RESOLUTION NO. R-2535

A RESOLUTION OF THE CITY COUNCIL OF THE CITY OF KIRKLAND APPROVING THE ISSUANCE OF A PRELIMINARY PLANNED UNIT DEVELOPMENT PERMIT AS APPLIED FOR IN DEPARTMENT OF COMMUNITY DEVELOPMENT FILE NO. P-PUD-78-25(P), BY RON STEWART DBA CAMBRIAN DEVELOPMENT FOR DEVELOPMENT OF 52 UNITS ON A 5-ACRE PARCEL, BEING WITHIN AN RS 8500 AND RS 5000 ZONE, AND SETTING FORTH CONDITIONS TO WHICH SUCH PRELIMINARY PLANNED UNIT DEVELOPMENT PERMIT SHALL BE SUBJECT.

FILE NUMBER P-PUD-78-25(P)

SUBJECT PRELIMINARY PLANNED UNIT DEVELOPMENT OF "SUN DANCER"

EXHIBIT C
 Site Plan
 P-PUD-78-25 (P)
 "SUNDANCER"

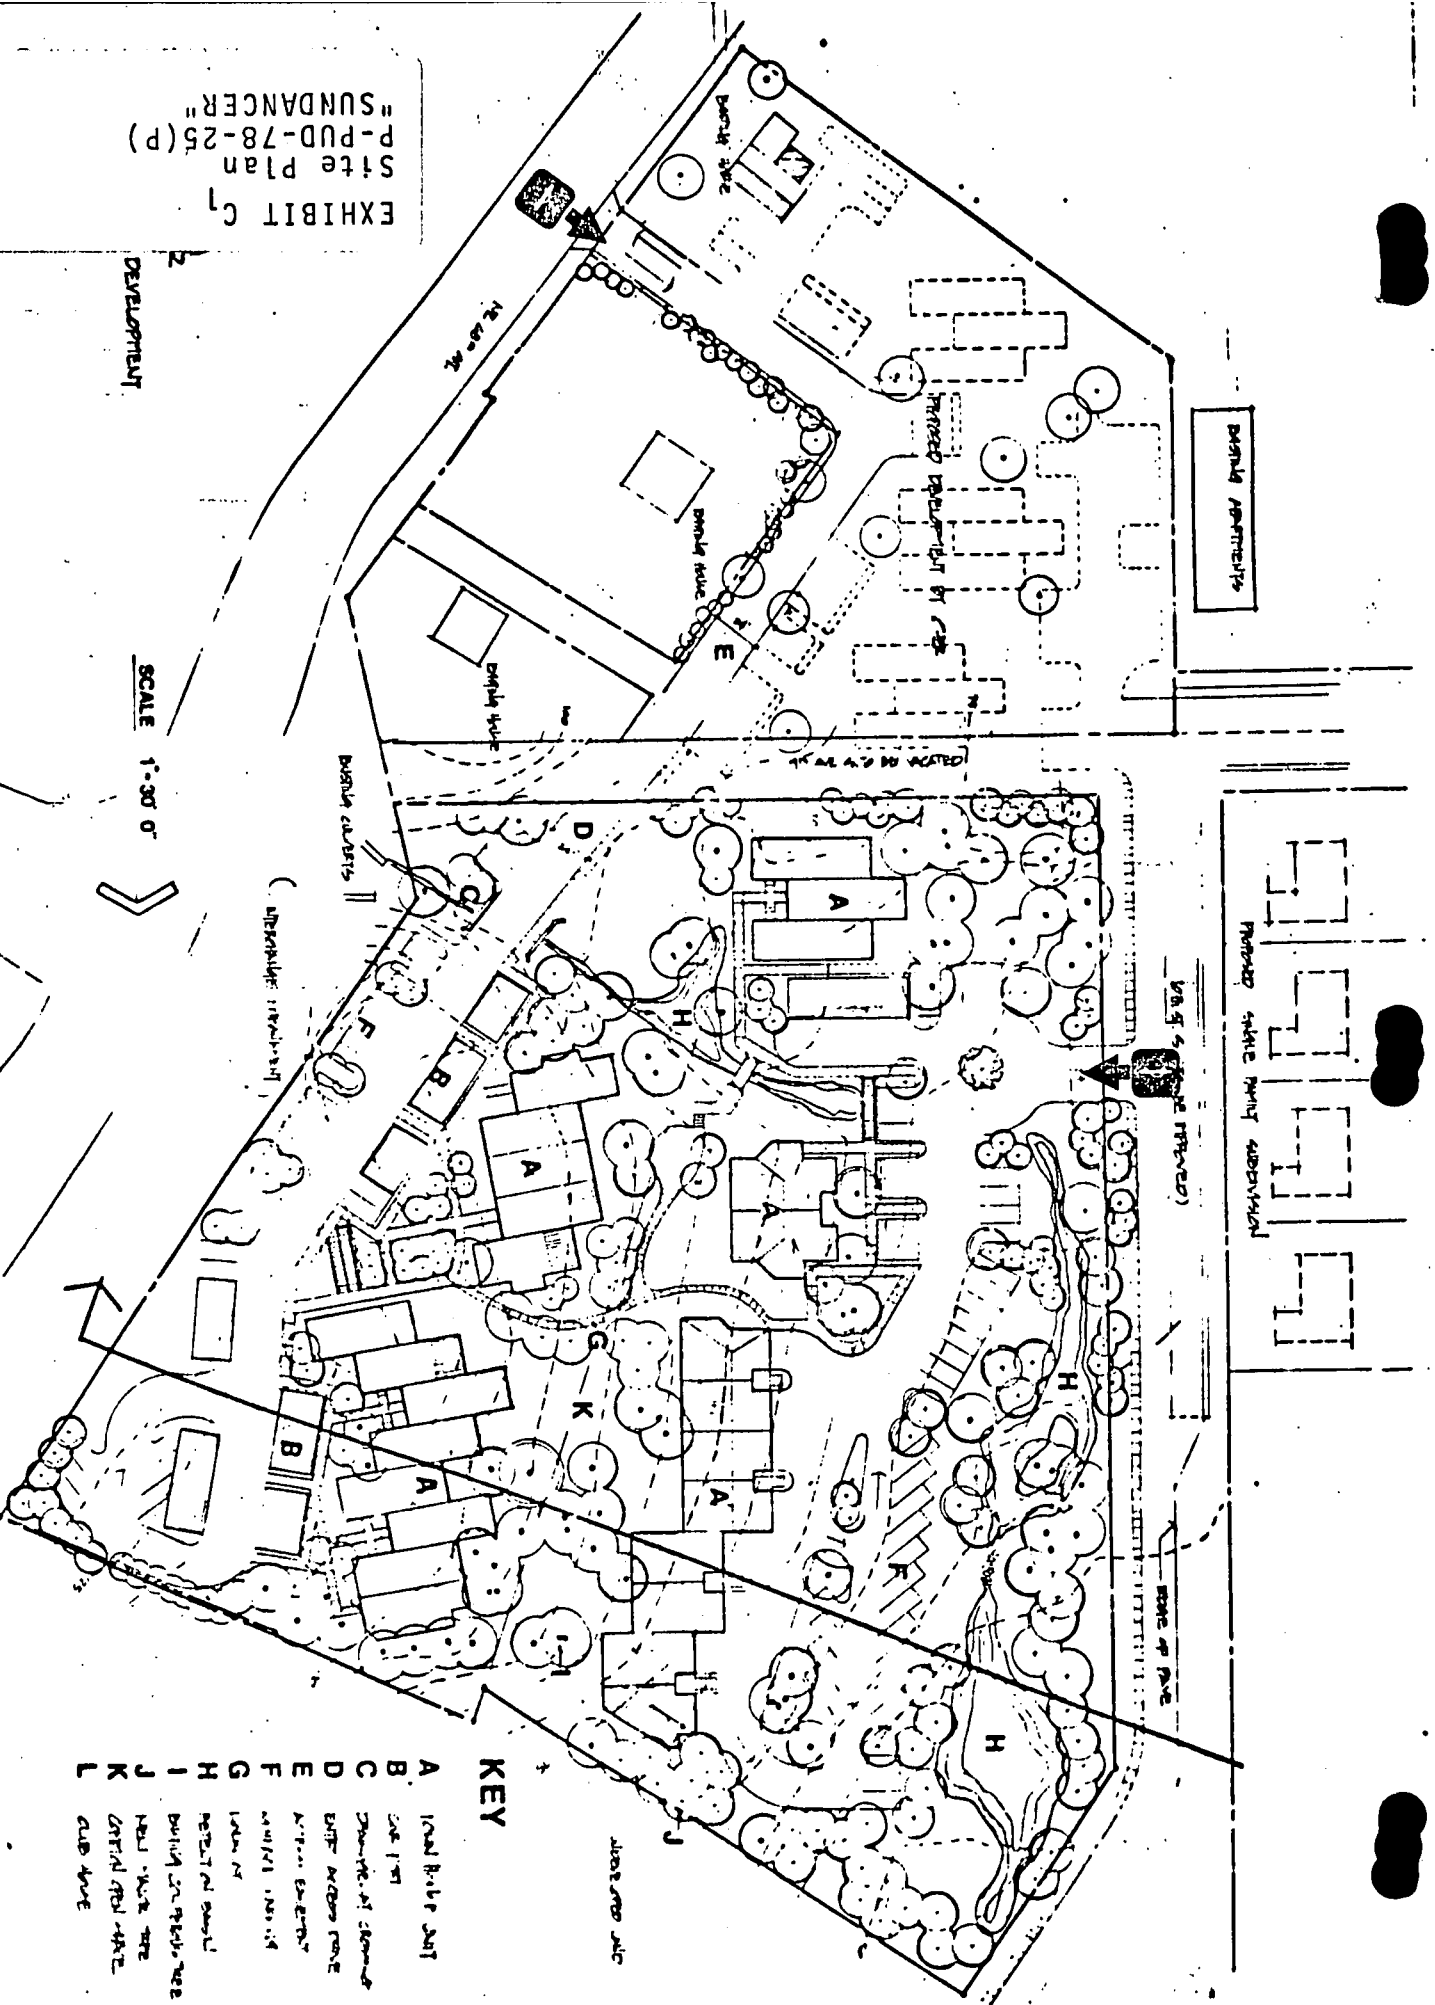
10. Hydrology. A culvert outlets on the southeast portion of the subject property. From this outlet a stream flows westerly to the western portion of the subject property and then swings northward to flow out of the subject property at the northwest corner (See Exhibit "C" - Site Plan). At the northwest corner the stream flows into a culvert which carries it beneath the right-of-way of Slater Avenue S. Water from this stream and perhaps also from subsurface drainage has created a wet condition on the western portion of the site. (See Exhibit "G" - Soils Report).

11. Vegetation. The northeastern portion of the site is a grassy hillside partially covered with Scotch Broom. The southern and western portions of the property are covered by dense deciduous growth of red alder, vine maple, big leaf maple, and a few scattered coniferous trees. The heavier growth of coniferous trees occurs at the northern edge of the subject property. The applicant has indicated major existing coniferous tree to remain on the site plan (see Exhibit "C" - Site Plan).

3. Topography. The subject property has some very steep grades, particularly in the eastern portions of the site. However, the proposal places structures, roadways, and other improvements in such a manner as to avoid the most severe grade constraints in the area. Grading plans indicate that modifications to the existing contours will be minimal with cuts and fills in the range of 5 to 10 feet maximum. This level of modification to existing topography should not present a constraint upon the approval of this development.

4. Hydrology. The applicant's proposal to more clearly define and collect the drainage way across the property is an integral part of the proposal. Prior to Final Planned Unit Development, detailed drawings of the indicated retention systems, including dams, ponds, and piping if necessary, should be submitted for review by the Department of Public Services. The water exiting the site after development should not be substantially inferior in quality or greater in quantity to that which currently exits the subject site during a 10 year storm. Further analysis should be done of the water now entering the subject property at the south-east corner from the existing culverts under the interstate. An analysis of the water there should determine its actual chemical content and identify means of treating the water to improve its quality before it is passed on down stream. This treatment is appropriate in view of the "public benefit" aspect of a Planned Unit Development. The applicants should also undertake a more intensive analysis of the drainage basin in the South Everest area for the purpose of identifying this property's role in that system. Boundaries for such system should include NE 68th Street on the east and south, 8th Street S. on the west, and Slater on the north.

5. Vegetation. The applicant's proposal to remove some of the trees on the site together with associated undergrowth will not represent a major environmental disruption. Much of the vegetation which is proposed to be removed is marginal in nature. However, the applicant should submit a detailed tree retention and landscaping plan along with application for Final Planned Unit Development indicating those trees 6" or greater in caliper and stating which are to be removed and which are to remain. This landscaping plan should indicate plant species to be placed as well as the size and spacing of materials at time of planting.
6. Soils/Geology. The major conclusions of the soils report indicate that these natural systems do not represent a constraint for the proposed project.

7. Streets. The study by the Transpo Group (see attached Exhibit "H") indicates that the added impact of 18 dwelling units accessing onto NE 68th Street from the subject property will not constitute a significant added increment of traffic volume to either current or full development potentials. For example, it is estimated that at full development the total traffic accessing onto the proposed access point of NE 68th, including the two properties immediately south of the subject property, would total less than 4% of total volume in the corridor. The revision to the project, to have 26 units instead of 18 use this access, does not represent a significant additional increment. 10th Street S. should be opened for the full length upon which it abuts the subject property. This should be to the standard 16 foot wide section prescribed by the Public Service Department.

The 28 foot wide access road which the applicants are showing between their southern property line and NE 68th Street crosses another individual's private property. As indicated on the drawings, this has been designed to a 28 foot wide road section, conforming to specifications of the Public Service Department. This access road appears to be adequate in both its dimension and configuration. However, the applicants should be required to illustrate with the Final Planned Unit Development the manner in which they propose to protect the residential properties to the southeast from the impacts, both visual and audial, of moving automobiles. If the applicants propose to use landscaping materials or structures, then this should be indicated with a detailed site design done at a scale of 1" = 20'. This should be a part of the detailed landscaping plan submitted with Final PUD.

8. Pedestrian Ways. The applicant should be required to provide 5 foot concrete sidewalks on the eastern portion of the 10th Avenue - 10th Street S. right-of-way as a part of that street improvement. Also, as a benefit to the general neighborhood and the public the applicant should, by final PUD, provide for pedestrian access over either their property and/or the abutting property onto NE 68th Street. The final alignment and configuration of such pedestrian access to NE 68th should be worked out between the applicant, the City, and any other private property owners prior to Final PUD review.

9. Domestic Water/Fire Hydrant. The applicant should indicate that there is adequate fire flow per the requirements of the Kirkland Department of Fire Services. They should also indicate on their revised Exhibit "D" (Grading/Utilities) that the four fire hydrants will also be installed.

However, some revisions to the site plan would be appropriate in order to more fully address policies in the Land Use Plan. These redesigns should minimize the percentage of impervious surface on the site, as well as provide a greater degree of buffering for the single family areas to north and to the west. This can be accomplished by:

- a. Redesigning the parking areas on the western portion so that the open asphalt areas are more broken up with berms and landscaped islands.

- b. Designating all of the "new major trees" along the western property line as evergreen coniferous trees which will serve to visually screen the project from the single family areas to the west on 10th Street S. Also, a 6' high earth berm should be provided the full length of the western property boundary of the subject property for the purpose of providing a visual and functional buffer.

5. Applicant shall indicate on the final site plan where additional earthen berms and landscaped islands will be added to further "break up" the open asphalt area.

8. With application for Final Planned Unit Development the applicant shall indicate on a revised site plan the location and specifications for lighting of all proposed parking areas.
